## **INQUIRY INTO DEVELOPMENT OF THE TRANSPORT ORIENTED DEVELOPMENT PROGRAM**

**Organisation:** Bayside Council

**Draft Bayside Council Submission on NSW Government's Transport Oriented Development Program**

**Figure 1** Proximity between Banksia Station precinct's southern boundary and Rockdale Station precinct's northern boundary.

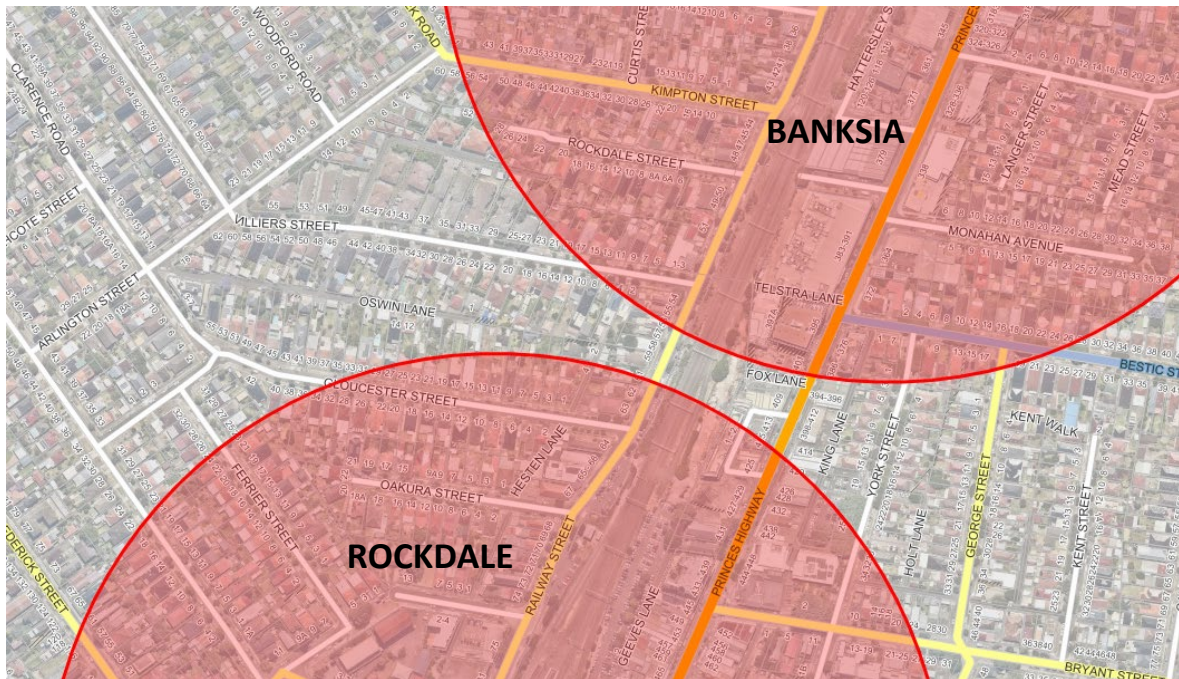
- b. **Proximity of Boundaries** - Rockdale and Banksia stations are close to each other and their radii almost intersect. This results in a narrow strip of sites that will not benefit from the policy changes (**Figure 1**). This will create a poor transition in built form between the two precincts.

Creating a corridor between/around the two station precincts would address this. As recommended in point 1(a) above, this should be mapped to ensure the boundaries are clearly demarcated.

**Figure 3** RTC Masterplan boundaries (left) (Source: Bayside DCP 2022) & RTC Design Excellence boundaries (right) (Source: Intramaps)

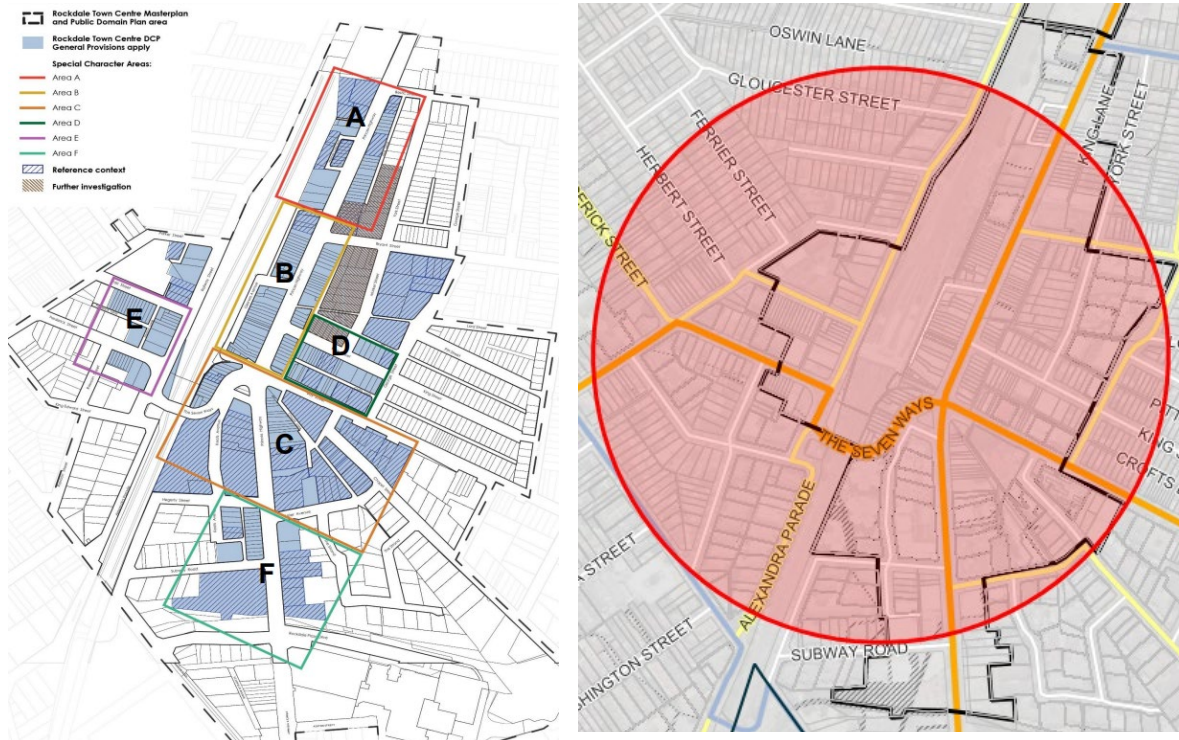
A significant portion of the Rockdale Station precinct area is subject to the Rockdale Town Centre (RTC) Masterplan, the majority of which is subject to Design Excellence under the Bayside LEP 2021 (**Figure 3**). All sites within the RTC Design Excellence area (excepting 307 Walz Street) are not subject to FSR controls. Furthermore, as part of the recent review and update of Council's planning framework, the planning controls relating

- i. **Rockdale Civic Section** – The Bayside Local Strategic Planning Statement (LSPS) lists finalisation and adoption of the Rockdale Masterplan and Urban Design Studies for the remaining civic section of the RTC as a planning priority. Council is concerned that the TOD SEPP will compromise the planning investigations currently underway for this area.

As raised in relation to the strategic context of Kogarah, Council is concerned that the proposed TOD provisions will consume potential development sites that could ultimately accommodate higher densities, and that any development may limit the medium and longer term plans for the RTC civic section.

**Figure 4 Bexley Draft Heritage Conservation Area.**  
*Note some sites are within the prescribed area (Source: Intramaps)*

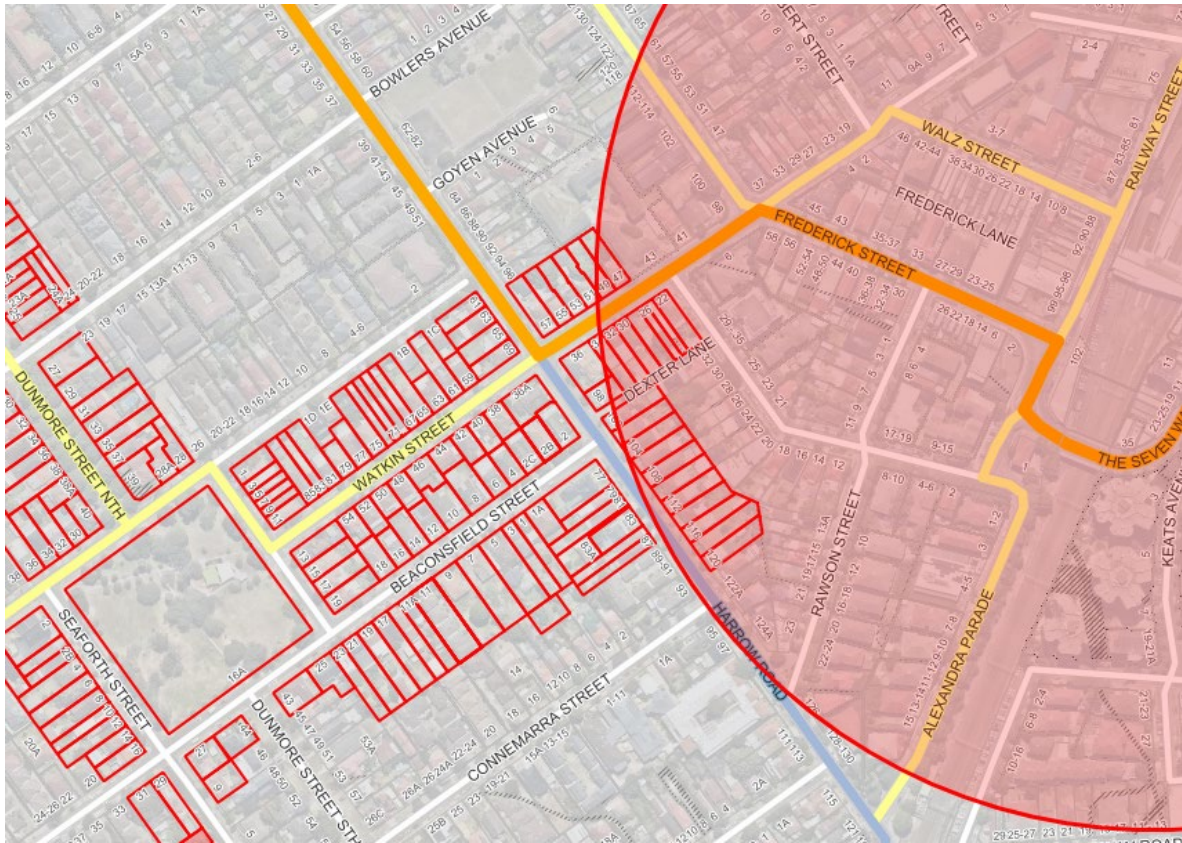
- ii. **Draft Heritage Conservation Area** – In 2020, Council initiated a Planning Proposal (PP) to create four Heritage Conservation Areas (HCA's) including Ocean View Estate, Bexley. Several properties along Harrow Road and Watkin Street are within the Rockdale Station precinct (**Figure 4**). The new TOD SEPP planning controls will apply in HCA's, which may undermine the objectives of the PP. Council acknowledges the need for more housing but believes that stringent controls are necessary to ensure the conservation of properties within HCA's.

**Figure 5** Half of Turrella Station precinct (shaded dark red) is excluded from residential intensification due to industrial precinct (IN1 zone) and parkland (C1 zone) (Source: Intramaps)

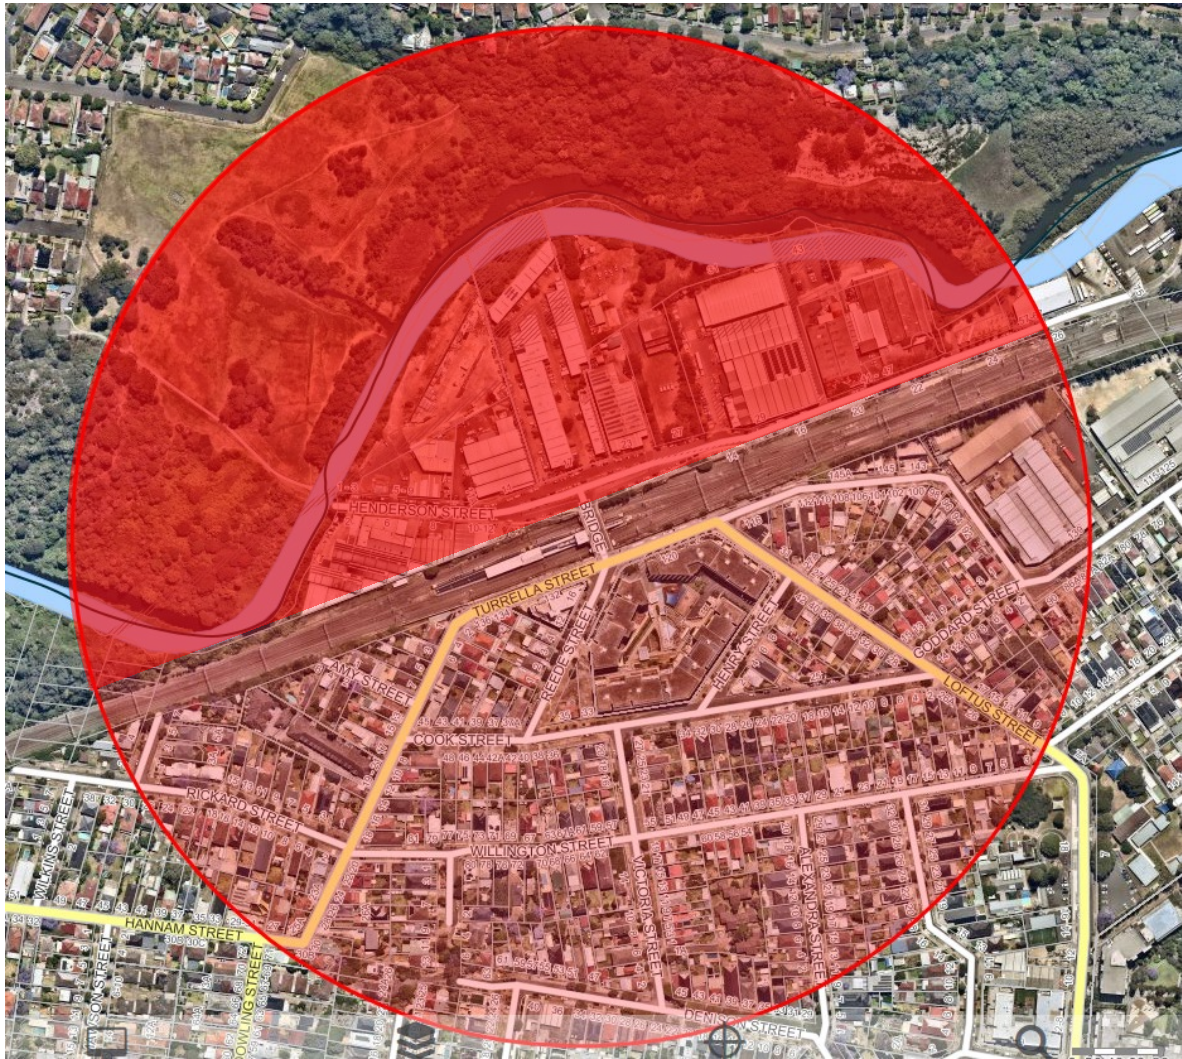
Turrella Station is located west of the centres of Wolli Creek and Banksia. The northern section of the prescribed area is partially zoned E4 General Industrial (between the Wolli Creek and East Hills train line) and is therefore unaffected by the proposed changes. North of Wolli Creek is undeveloped park and bushland located in the Canterbury-Bankstown LGA. The southern portion of the prescribed area is where the proposed controls will largely apply (**Figure 5**).

- i. **Open Space** – Open space to the north is not easily accessible due to the industrial precinct and river limiting permeability, and there are limited open space opportunities to the south due to the topography of the land. The opportunity to acquire additional open space to serve an increased density of development, especially in the absence of a s.7.11 Contributions Plan, is very limited.
- ii. **Permeability** - The Turrella Station precinct mostly consists of low density detached housing. A small pocket of R4 High Density Residential zoned land is located immediately south of the station and contains two Residential Flat Building developments, roughly of similar scale to the proposed SEPP controls.

The developable area (low density housing) consists of small sites with average lot sizes of less than 500 sqm. However, the street blocks are large and do not provide efficient walking routes to the station. The proposed SEPP controls do not enable the delivery of through site links, which can enable enhanced walkability. The existing small lot sizes may be challenging to consolidate, which could result in isolated sites. The absence of a minimum lot area carries the risk of unrealistic development proposed of small sites.
